DRAINAGE SUMMARY

PROJECT : INTERSTATE ROUTE H-3

F. A. I. PROJECT NO: 1 - H-3-(150)

STATE OF HAWAII DEPARTMENT OF TRANSPORTATION HIGHWAYS DIVISION
DRAINAGE PLAN
INTERSTATE ROUTE H-3 F.A.I. PROJ. NO. I-H3-1(50)
SCALE: 1" = 40' DATE: JUL., 1988
SHEET No. H8 OF 54 SHEETS

INLET STRUCTURE AT STA. 449+60 o/s 53' RT.

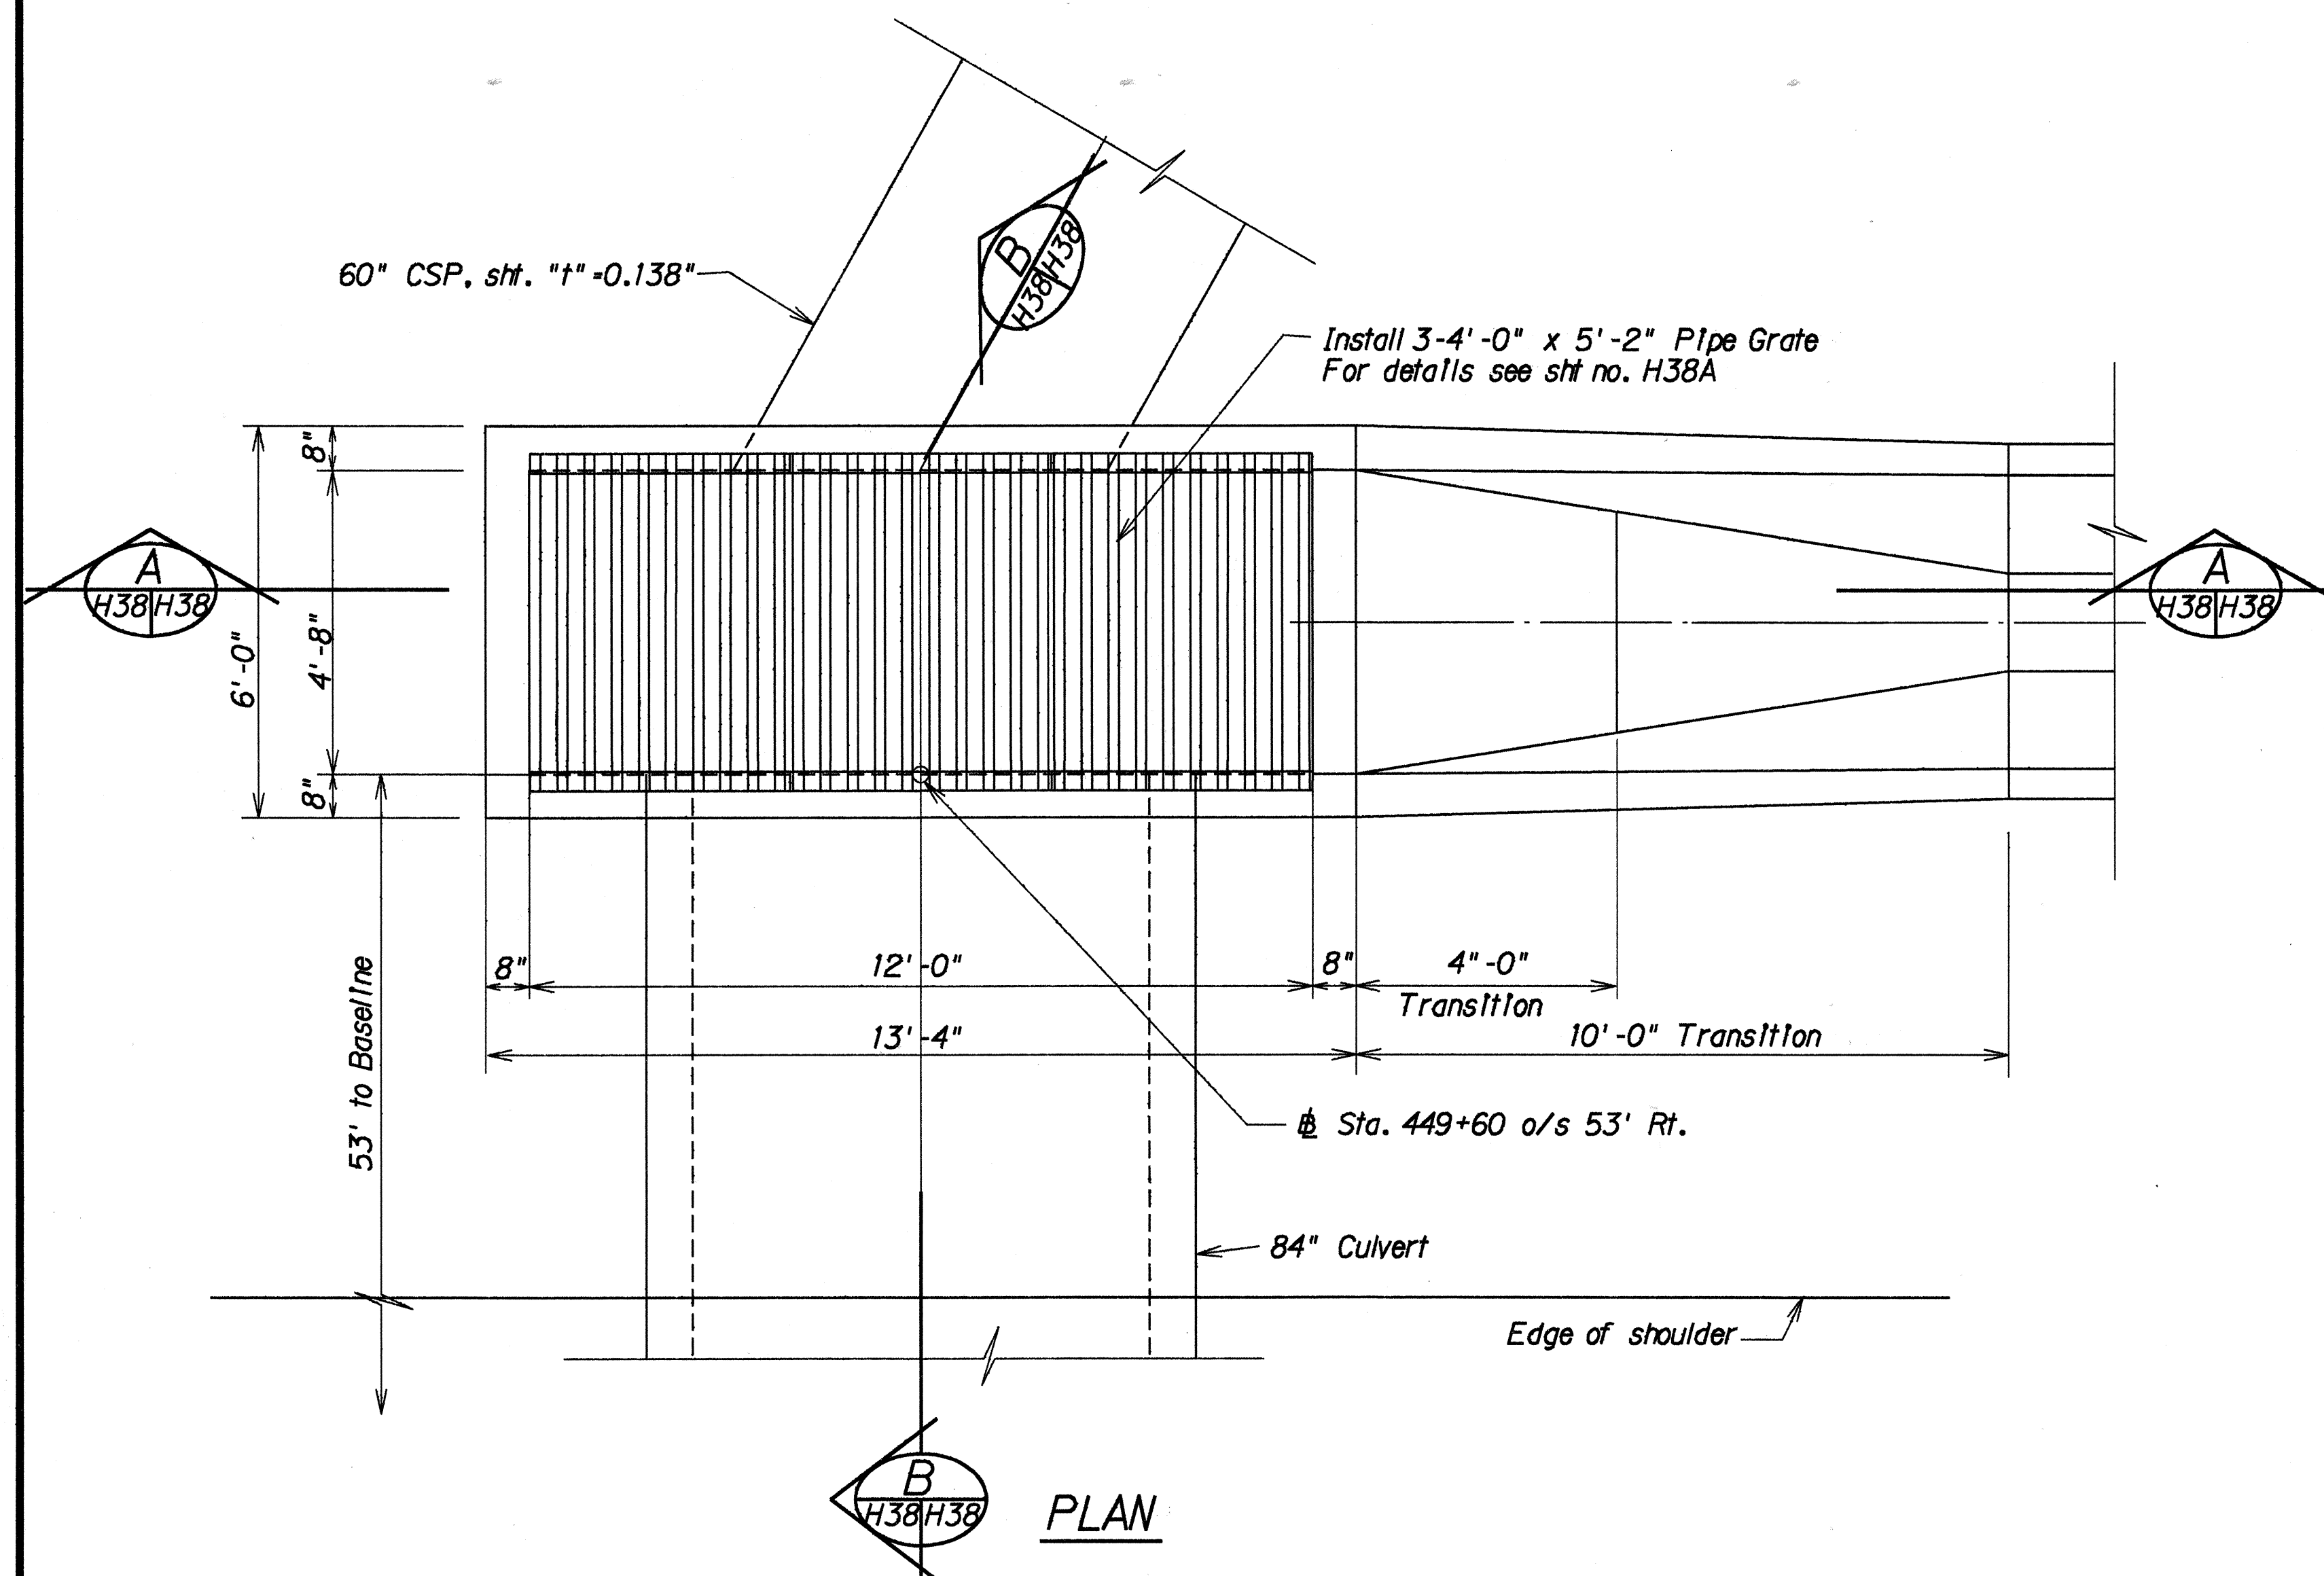
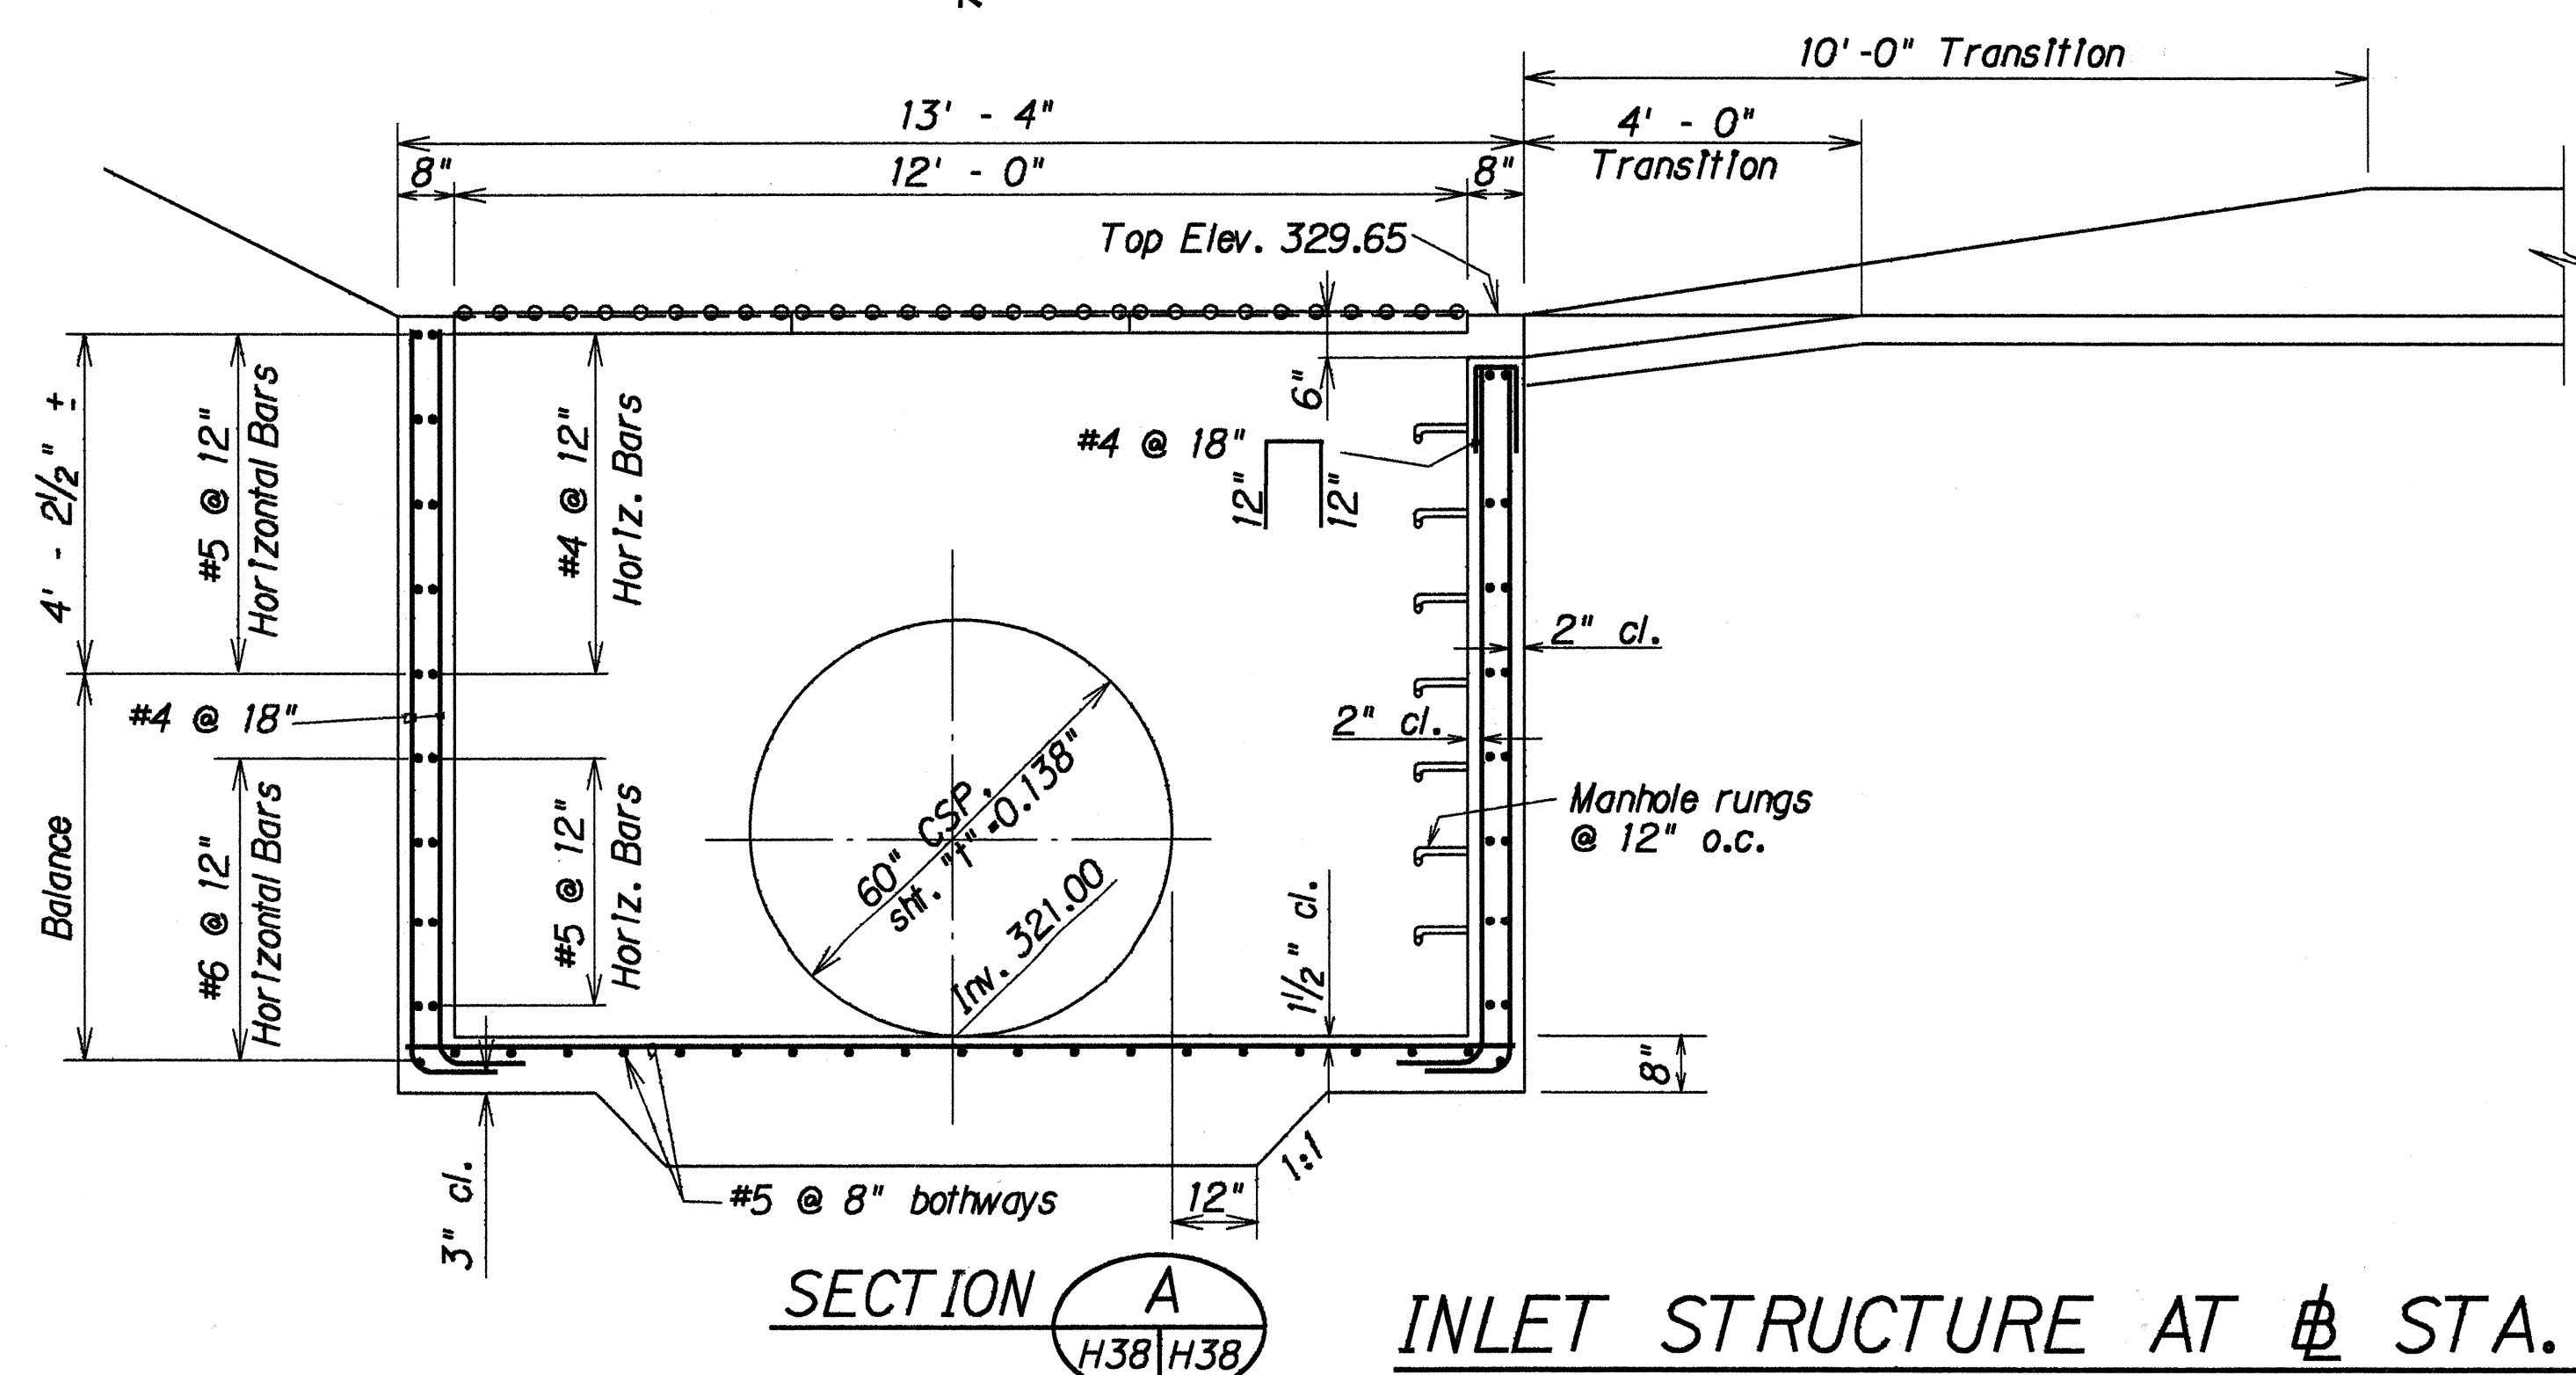
2/14/90 Modified Inlet Structure
DATE REVISION
